4 April 2019

**SCAP REFERRAL – AMENDMENT – DA 090/E004/18
COUNCIL FURTHER COMMENTS
RETAIL DEVELOPMENT - 10 ANZAC HIGHWAY EVERARD PARK**

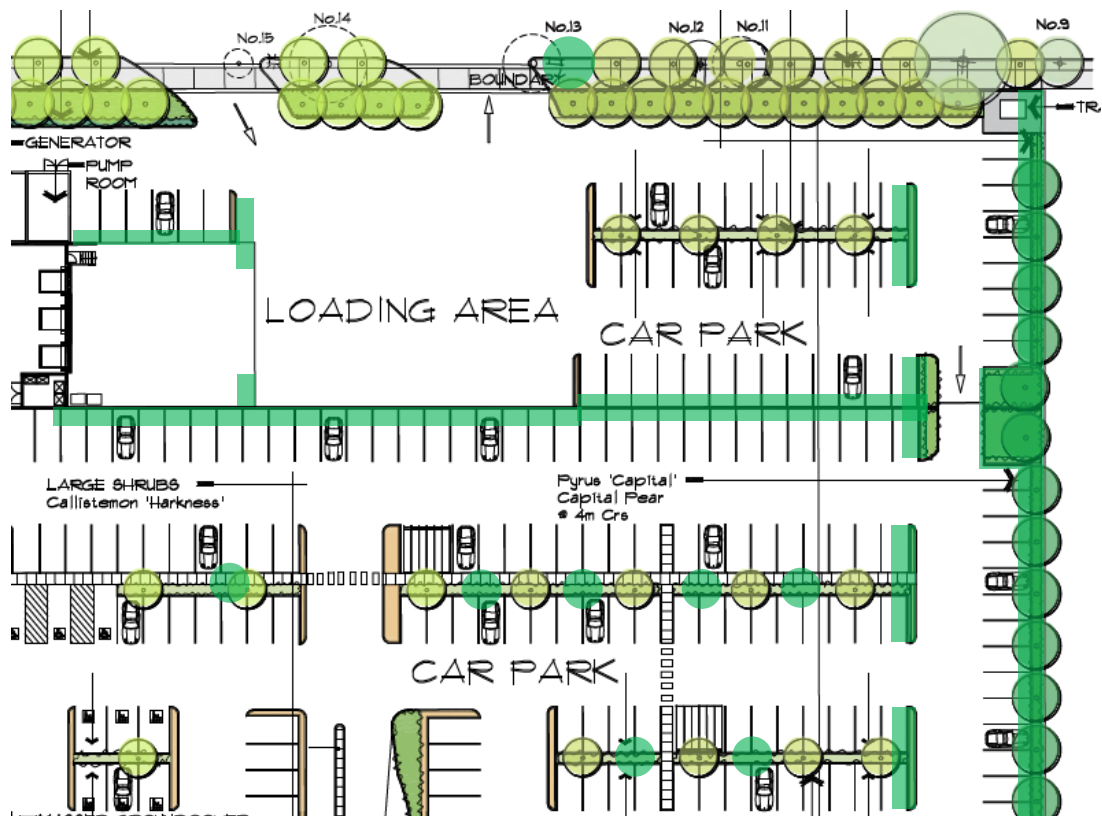
- The consolidated waste and delivery servicing area at the western end of Maple Avenue and limited access openings, movements, screening gates, fences and landscaping is positive.
The deletion and exclusion of heavy and emergency vehicle access to Leader Street is positive.
The tenancies waste management and delivery arrangements as part of vehicle entry off Anzac Highway, use of smaller trucks and loading in normal parking spaces area is effective;
- Main waste and delivery area on Maple Avenue have limited as far as possible the extent of crossovers relative to size of trucks and provided for extensive borders of screening landscaping and fences.
It is unclear if there are matching fence sliding gates to Maple Avenue to close-off and secure the area from visibility and access when area is not being

Further, fence returns on loading dock area, increased landscaping could aid screening and containment of noise. See below;

The rear service and delivery area off Maple Avenue accommodate vehicles up to a maximum length of 16 metres and access openings be secured and closed-off from view by sliding gates (noiseless system) matching the boundary fencing adjacent to Maple Avenue;

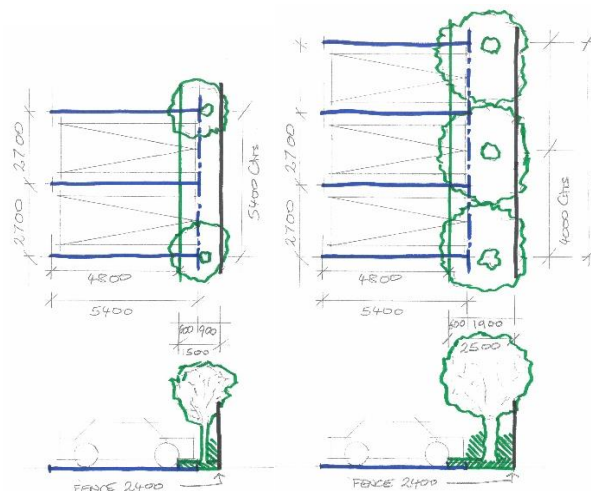
- The rear eastern boundary landscaping annotation indicates trees (*Pyrus 'Capital' Pear*) at 4 metre centres but are shown at junction per 2 car spaces which would be 5.4 metres centres. Further, the width of the planting strip, including under car wheel stop area, is only 1.5 metres wide, and only 0.8 metres wide clear of nominal vehicle in parking position. This landscape strip should be increased in width to at least 2.5 metres (and 1.8 metres clear of vehicles) to afford space for trees at 4 metre centres and substantial under planting to create an attractive and effective continuous buffer and soft screen to the property to the east.

No indication is given on site/landscaping plans of fencing along the rear eastern boundary, but the Acoustic Report nominates a 2.4 metre high acoustic barrier.

The rear eastern boundary be fenced with a compatible appropriate quality finish continuous 2.4 metre high acoustic barrier, and the associated landscape strip be increased in length to the road boundaries (including past transformer

location) and in width to at least 2.5 metres (and minimum 1.8 metres clear of vehicles) to accommodate the proposed row of trees at 4 metre centres and appropriate substantial under planting to form an attractive and effective acoustic and continuous landscape buffer and soft screen to the property to the east;
